## Gate Burton Energy Park Targeted Consultation - Nov 2022

### Consultation Information Leaflet

# Localised changes to indicative Order Limits

### 1. Kexby Lane East

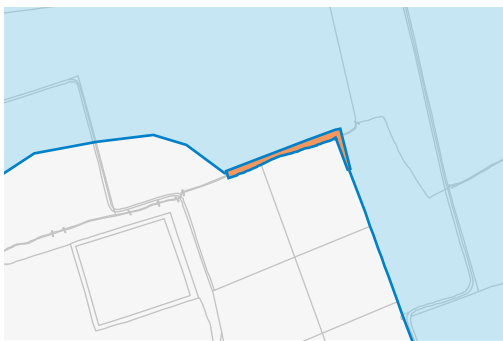
Transport and access requirements.

The Order Limits have been changed to accommodate the potential for areas of vegetation removal along the highway. This will ensure there is sufficient visibility for vehicles to safely access the construction compounds.

### 3. Within site - adjacent to main construction access

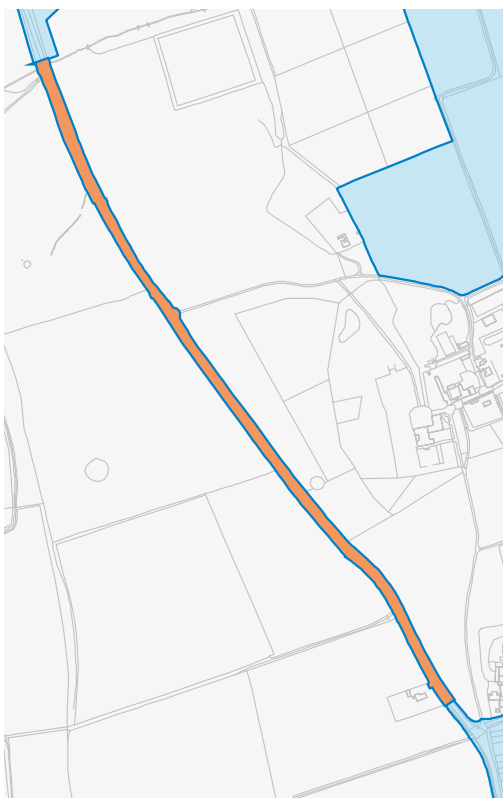
Due diligence.

The Order Limits have been adjusted to align with the ownership and field boundary.

### 4. A156 - west of Gate Burton

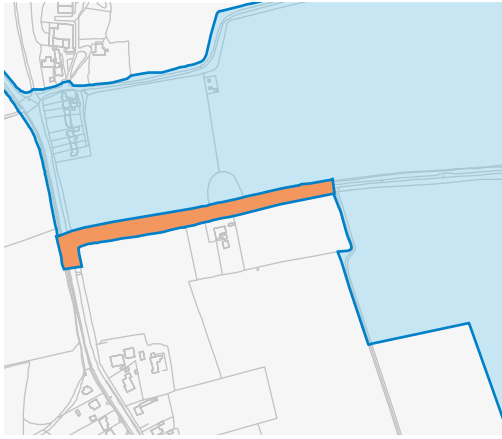
Engineering and feasibility.

The Order Limits have been changed to allow for connection to an existing water main along the A156 - enabling provision of a water supply directly to the sub-station and battery storage facility.

The exact point of connection is still to be determined and will be confirmed in the detailed design.

### 6. A156 – 1500 (Stow Park Road) / Littleborough Road junction

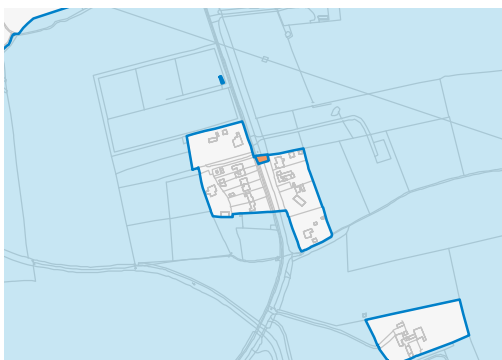
Transport and access requirements.

The Order Limits have been changed to accommodate highway improvements at this junction.

This is to accommodate abnormal indivisible loads travelling to the Solar and Energy Storage Park (north) and the Grid Connection Corridor (south).

### 8. A156 South of Marton (southern extension)

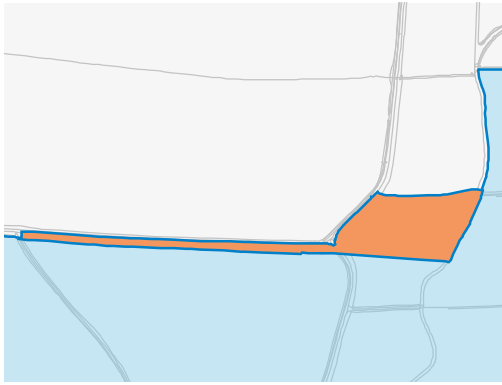
Transport and access requirements.

The Order Limits have been changed to accommodate the potential for areas of vegetation removal along the highway. This will ensure there is sufficient visibility for vehicles to access the proposed Grid Connection Corridor safely.

### 9. Land south/east of Broad Lane and Headstead Bank

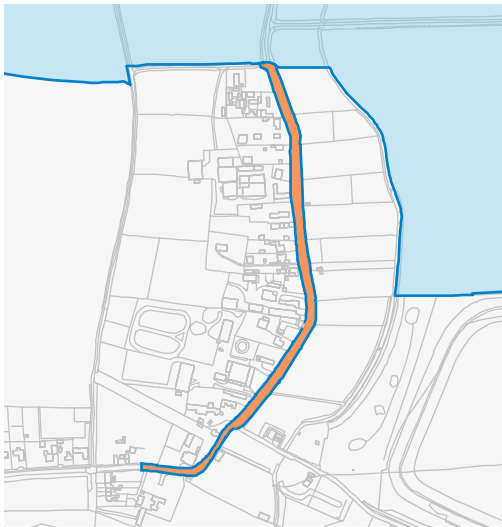
Engineering and feasibility.

The Order Limits have been widened to follow the field boundaries, which will allow flexibility for installation of the 400kV cable connections from Gate Burton Energy Park to the substation.

### 10. Headstead Bank/Town Street, Cottam

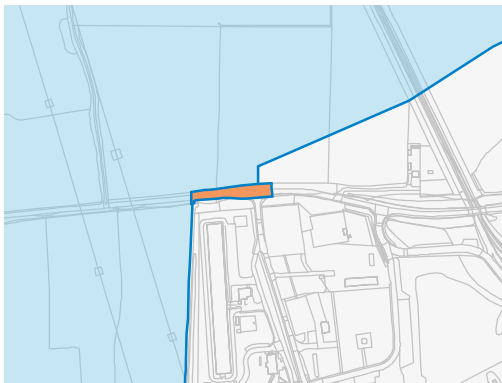
Transport and access requirements.

The Order Limits have been changed to allow for abnormal indivisible loads accessing the Grid Connection Corridor. Improvements may need to be made along this stretch of road to enable access for larger vehicles.

### 11. Cottam Road (eastern extension)

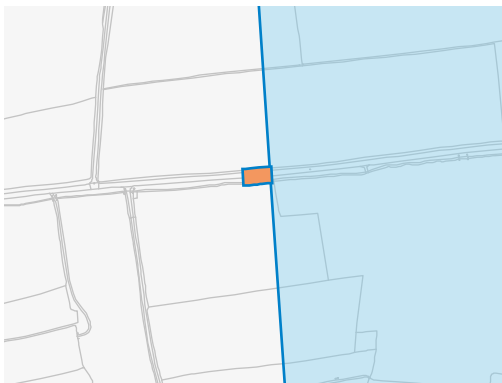
Transport and access requirements.

The Order Limits have been changed to accommodate the potential for areas of vegetation removal along the highway. This will ensure there is sufficient visibility for vehicles to access the proposed Grid Connection Corridor safely.

### 13. Green Lane/Rampton Road Junction

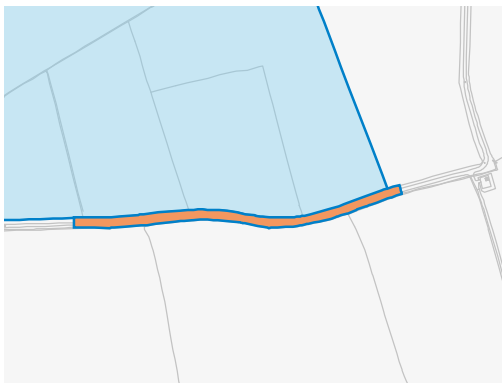
Transport and access requirements.

The Order Limits have been changed to allow for abnormal indivisible loads accessing the Grid Connection Corridor.

Improvements may need to be made to the junction to enable access for larger vehicles turning.
